Subject: **POWER LED DOES NOT ILLUMINATE**

Model: **PVM-5310**

Serial No: **5,001,611-5,001,810**

Figure 1

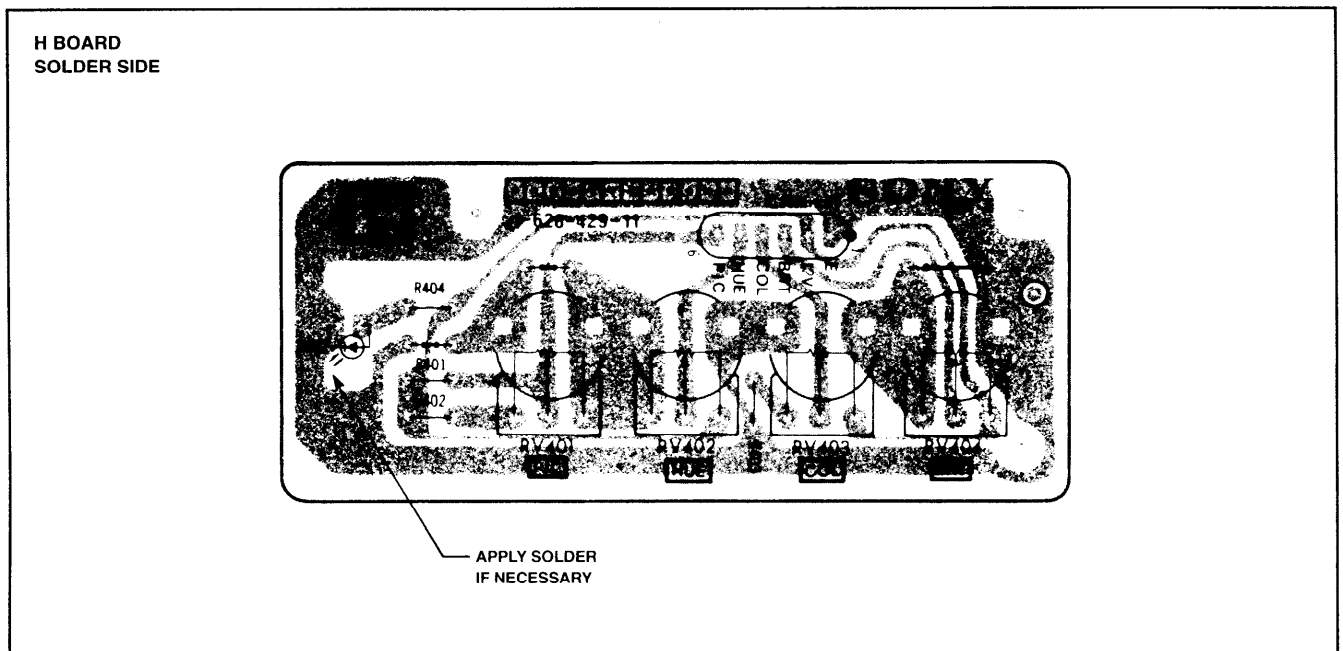
The power LED may sometimes not illuminate due to a poor solder joint on the H board. Should this occur, observe the solder side of the board near LED 401 and, if necessary, apply solder to the affected area of the board.
